THE CITY OF DURHAM TRUST

21 November, 2022

**DM/22/01981/RM Reserved matters application for 470 dwellings
(appearance, landscaping, layout and scale) pursuant to DM/20/03558/OUT,
land to the east of Regents Court, Sherburn Road, Durham City**

Multi-user paths and connections (requirement u)

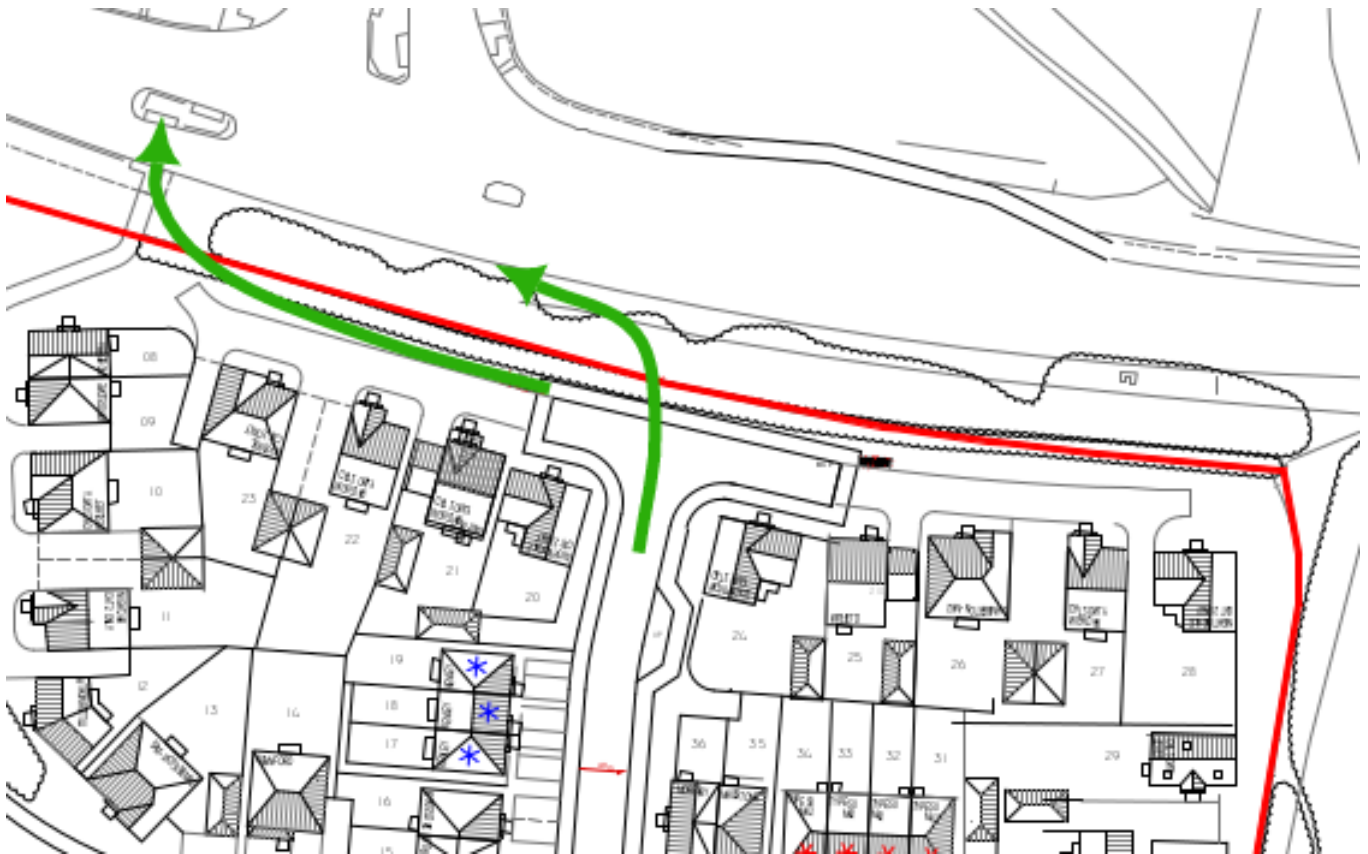
Recreational paths within the site are confined to a route parallel to the spine road and paths within the buffer along the southern boundary of the site. Paths appear to be pedestrian-only, being a similar width to the 1.8m footways, rather than multi-user. The approved Masterplan included a pedestrian route along the historic field boundary marking the north-eastern part of the site. This is no longer shown as a path, but the Trust welcomes the improvement in alignment in the recent revision.

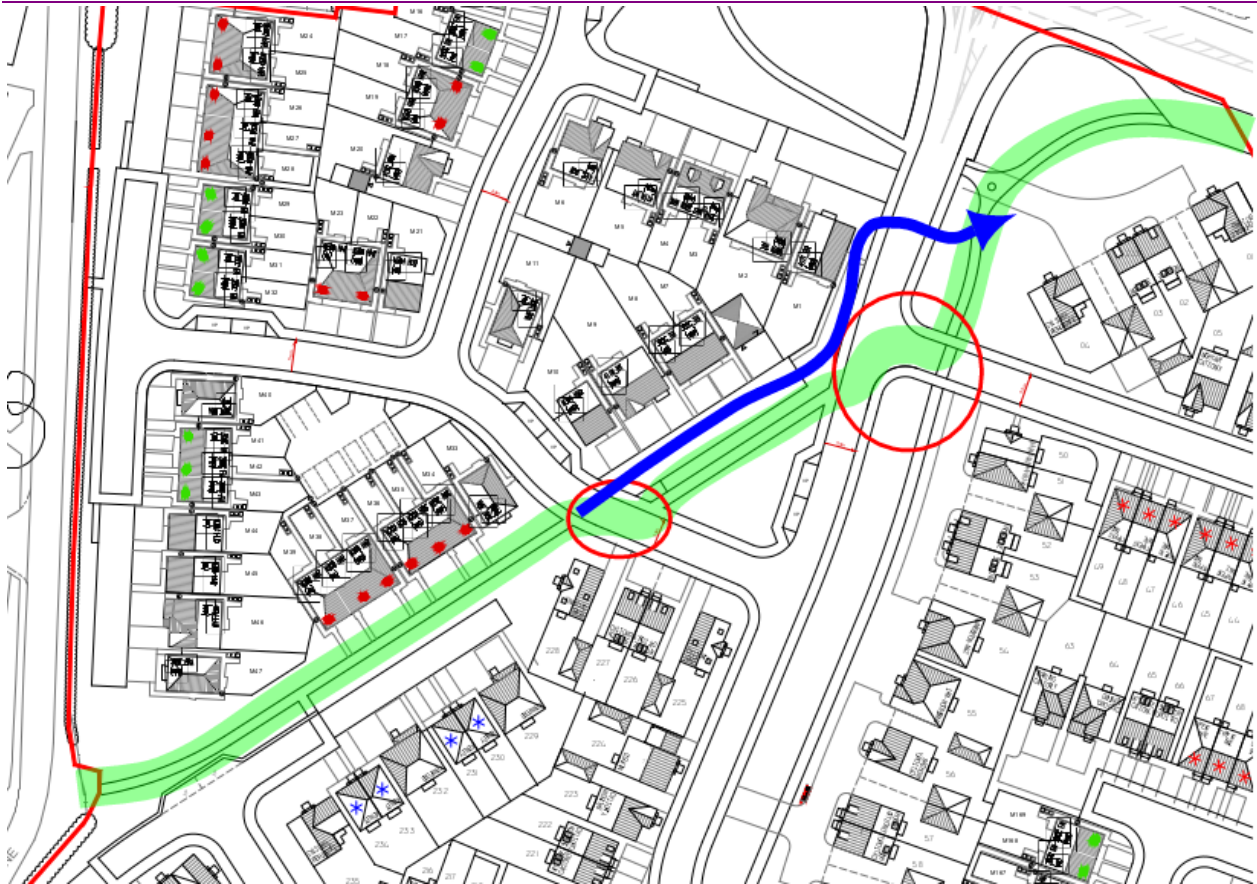
The Trust was critical of the approved Masterplan with its lack of clarity regarding which internal paths and external connections would be suitable for cycling. It appears from the submitted plans that the Reserved Matters application has provided no cycle paths within the site. The outline application envisaged a cycle route linking Bent House Lane and Damson Way, potentially rerouting the National Cycle Network Route 14. Here below are the remains of that proposal, highlighted in green on an extract of the submitted site plan.

The alignment of the western part of the route has been improved in the latest revision, but in contrast with the approved 'Masterplan' the rest of the route is still illegible, disjointed, and clearly no wider than the 1.8m footways. It does not appear to be intended as a cycle route, and nor do any of the other connections to Bent House Lane. At Sniperley Park the County Council's response to the developers includes mention of separating cycle and walking paths to comply with LTN 1/20. The Trust suggests that the connections onto Bent House Lane and other links within the site should have cycle paths at carriageway level, with pedestrian paths alongside at footway level to avoid conflict.

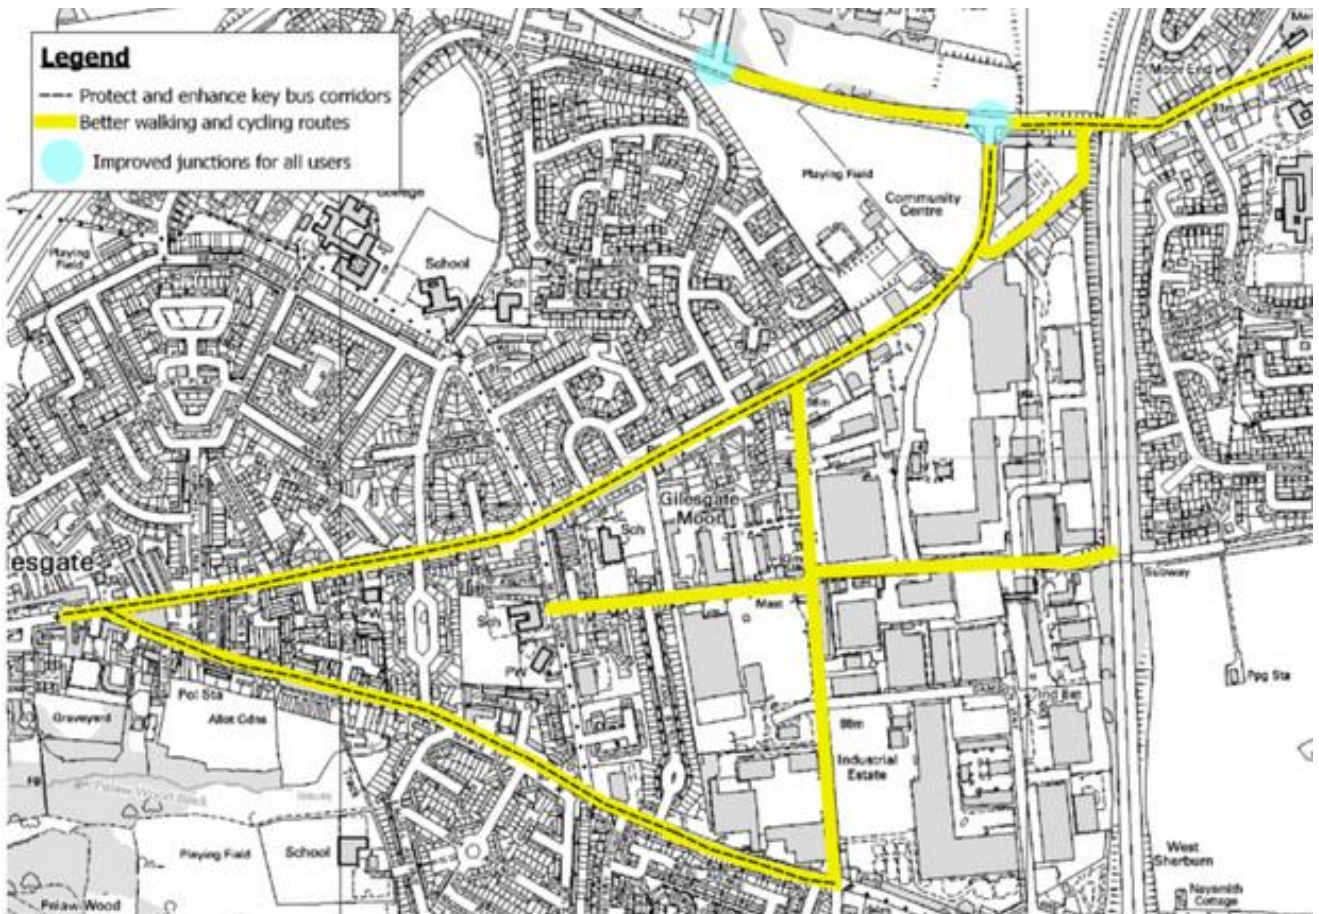
The junctions circled in red above need to be redesigned to give pedestrians and cyclists safe and direct access to the next section of the route. The blue line shows how this might be achieved, by adopting the access to some of the houses as a pedestrian and cycle way, and realigning the route to cross the main access road at right angles to improve safety. A further improvement could be made by introducing a bend in the access road to allow the pedestrian/cycle route to be straightened further, and reducing motor vehicle speeds at the crossing.

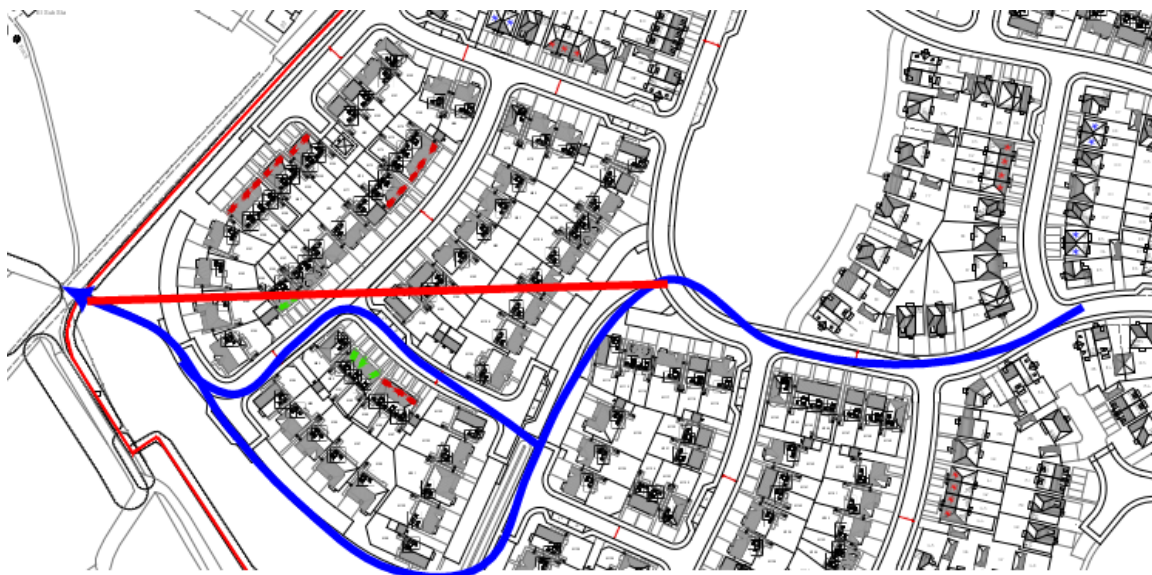
The Trust welcomes the addition, in the latest revision, of a footpath connection to the pedestrian crossing point at Damson Way. An additional footpath/cycleway connection to the A181 further east, from the access road which terminates on the northern site boundary, would beneficially reduce active travel distances from the whole of the eastern part of the site to Damson Way. The Trust would like to see this provided. Such a connection would, for example, reduce the overall walking/cycling distance to the nearest secondary school. Possible routes are shown below.

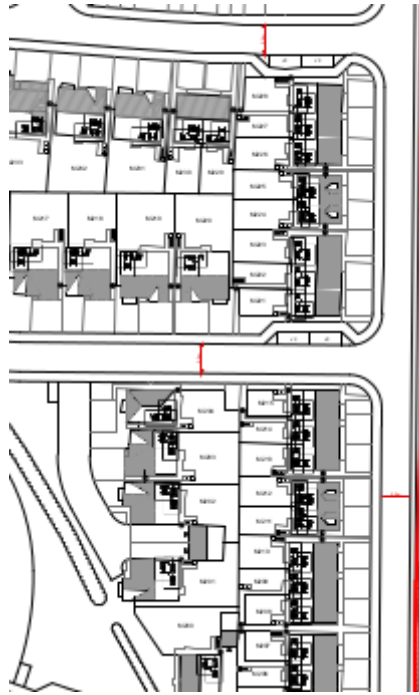
The detailed plan for access at the south-west corner of the site shows a chicane barrier. Use of this type of restriction is strongly discouraged by LTN 1/20 and this should not be installed. Any anti-social behaviour should be dealt with initially via enforcement. Barriers that can impede access for disabled users and those with non-standard cycle equipment should be a last resort.
